Report No. 10CFR21-0114

**10CFR21 REPORTING OF DEFECTS
AND NON-COMPLIANCE**

COMPONENT: Subcover assembly P/N 1A-7846 and machined subcover P/N 03-362-04-AH

SYSTEM: Emergency Diesel Generator

Figure 1: Outline Drawing of Subcover

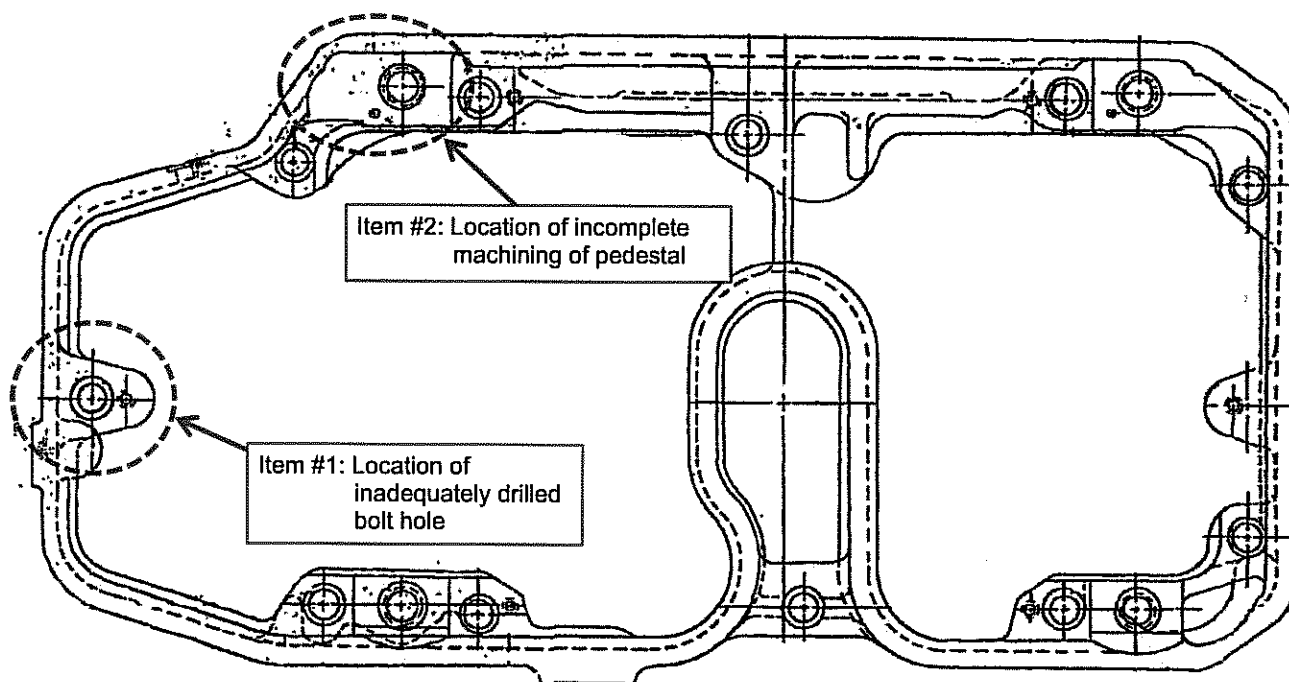
Engine Systems Inc. (ESI) began a 10CFR21 evaluation on November 18, 2016 upon notification of an issue with a subcover assembly at Perry Nuclear Plant. Attempts to install the subcover on their Enterprise diesel engine revealed two issues that prevented successful installation. First, one of the bolt holes was not fully machined through the entire depth of the subcover. Though the bolt could be inserted into the top of its corresponding hole, it would not pass completely through. The second issue was an interference between the rocker arm shaft and its mating pedestal. It was found that incomplete machining of the pedestal prevented the shaft from sitting flat on the pedestal.

Photo 1: Visual Depiction of Inadequately Drilled Bolt Hole

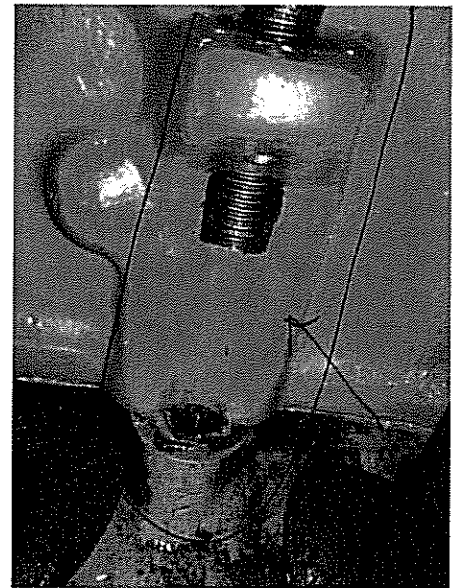
Item #1:

The issue regarding the inadequately drilled bolt hole would be detected during installation since it would prevent the bolt from passing through the hole. Therefore, it is determined this issue would have no impact on operability since the cover could not be installed with an incompletely drilled bolt hole.

- a) Inspect for the bolt hole (item #1). If rework is necessary, drill through to a diameter of 13/16".
- b) For the incomplete machining of the rocker arm pedestal (item #2), first remove the installed dowel which has 0.000" to 0.001" clearance. Then machine a 2" radius relief at the affected area. All other dimensions such as pedestal height shall remain unchanged.

Photo 3: Actual Machining

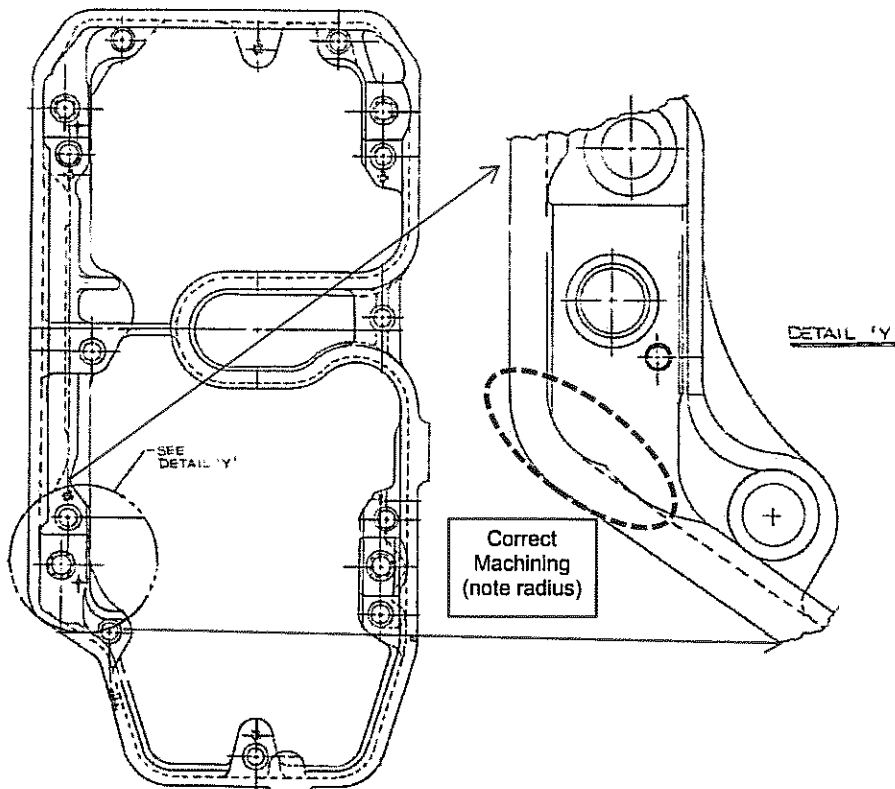
Item #2:

Incorrect Machining (insufficient radius)

With regard to the incompletely machined pedestal, there is the potential that a customer could install the rocker arm shaft without detecting this issue. In this situation, the shaft will partially fit on the pedestal and the bolt will thread into subcover; however, the shaft will not seat fully on the pedestal. This prevents full contact with the pedestal and inhibits adequate preload throughout the bolted joint. If a customer were to install the rocker arm shaft (with mating rocker arms, pushrods, etc) onto the engine without realizing this issue, operability and durability of the engine would be compromised. This could present a substantial safety hazard.
